**ADDENDUM NO. 1
Issued December 16, 2010**

**“REQUEST FOR BIDS
FOR
PURCHASE AND INSTALLATION OF A NEW
INSTRUMENT AIR COMPRESSOR
AND ASSOCIATED EQUIPMENT FOR THE
MID-CONNECTICUT POWER BLOCK FACILITY”
(RFB Number 11-OP-005)
(RFB Issued November 22, 2010)**

This Addendum consists of the Connecticut Resources Recovery Authority's (CRRA) changes to two items in the RFB Package Documents and CRRA's responses to questions that were posed at the pre-bid conference and site tour on Wednesday, December 8, 2010 and written questions that were received by CRRA by 3:00 p.m., Friday, December 10, 2010, the deadline specified in the Instructions To Bidders for the submission of written questions.

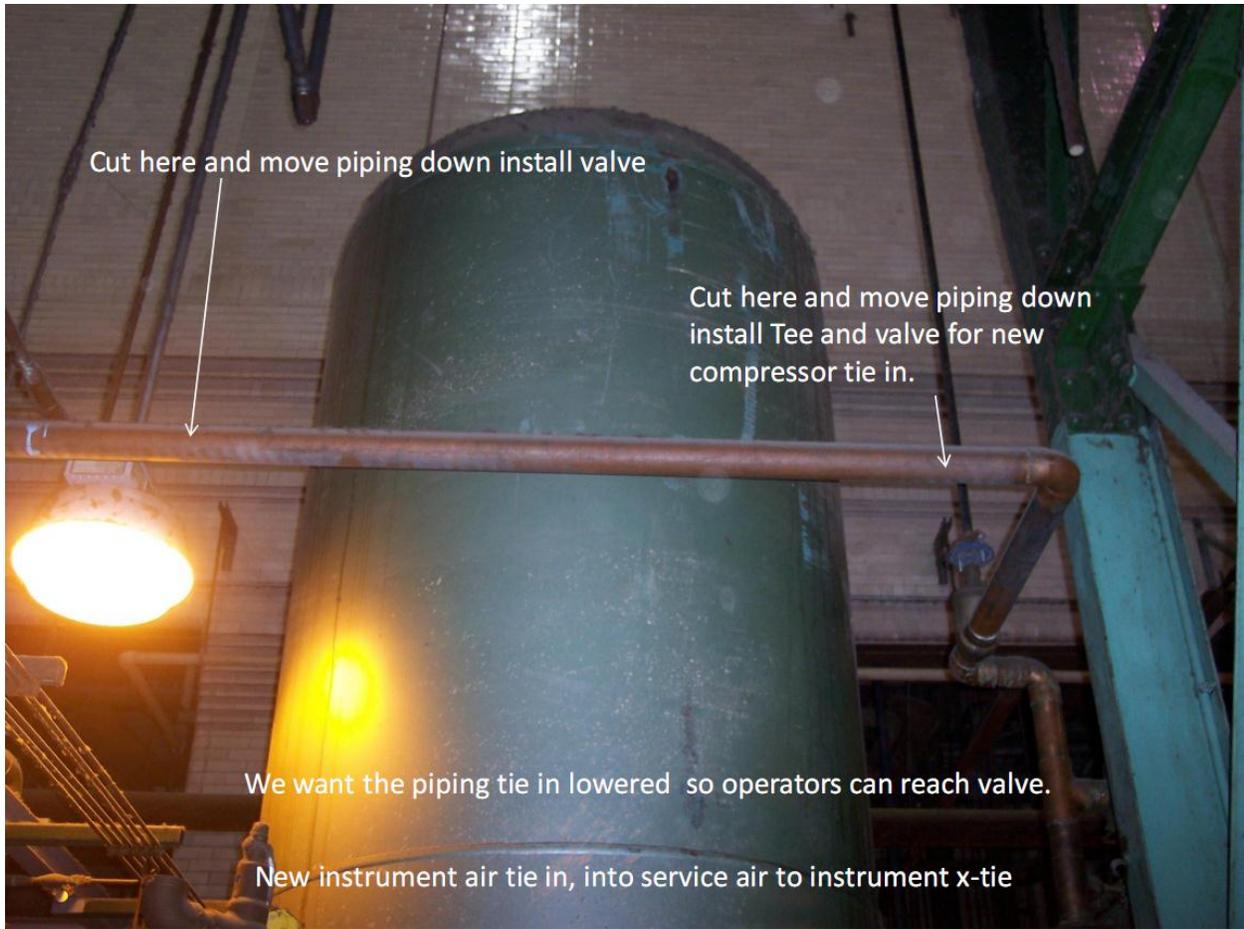
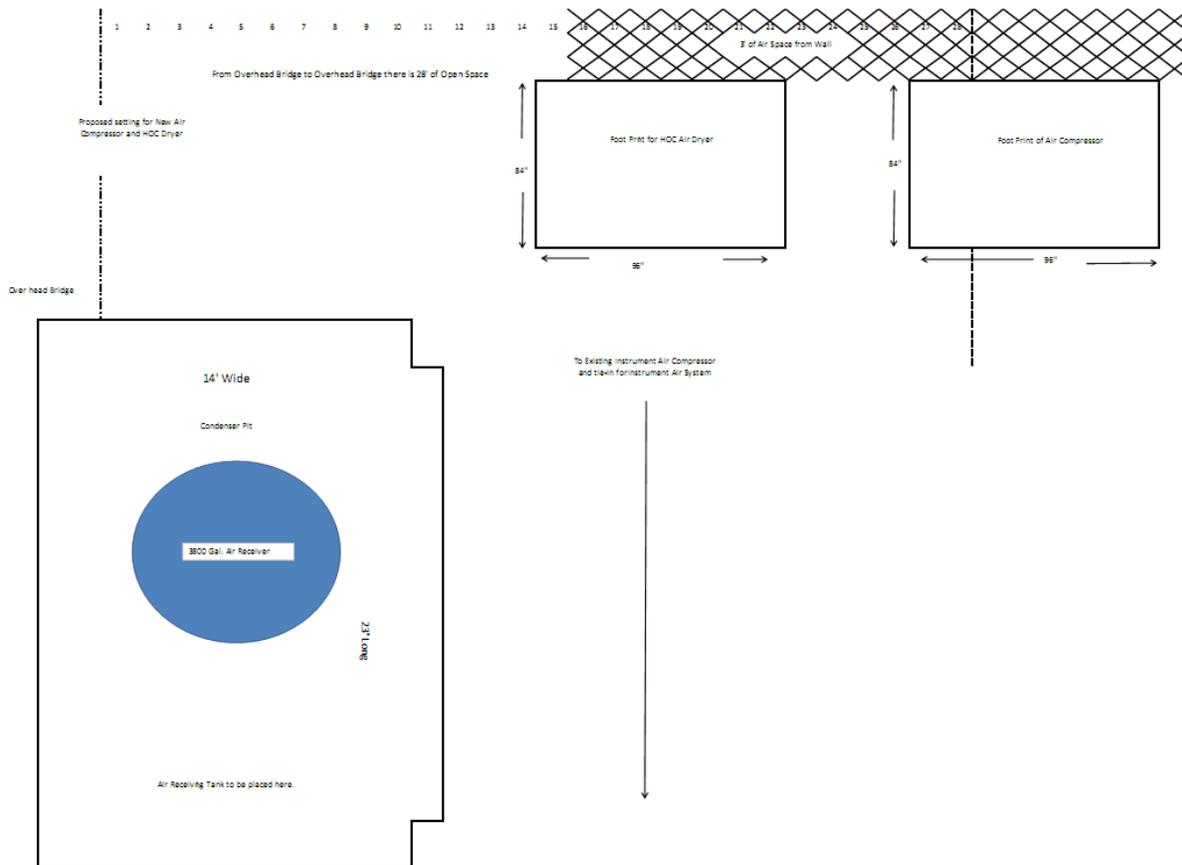
Exhibit A, "Technical Specifications," to the Agreement is modified to include the picture at the end of this Addendum depicting the layout of the air tie-in. This picture has also been posted on CRRA's web site on the "Business Opportunities" page.

2.4	Question	Provide a schematic diagram of the intended equipment layout and interconnecting piping and associated devices between the compressor-dryer-tank, as well as the tie-in to the existing instrument air pipeline.

Answer	See the attached sheet, which is made a part of the Technical Specifications. The attached sheet has also been posted on the CRRA web site on the “Business Opportunities” page.
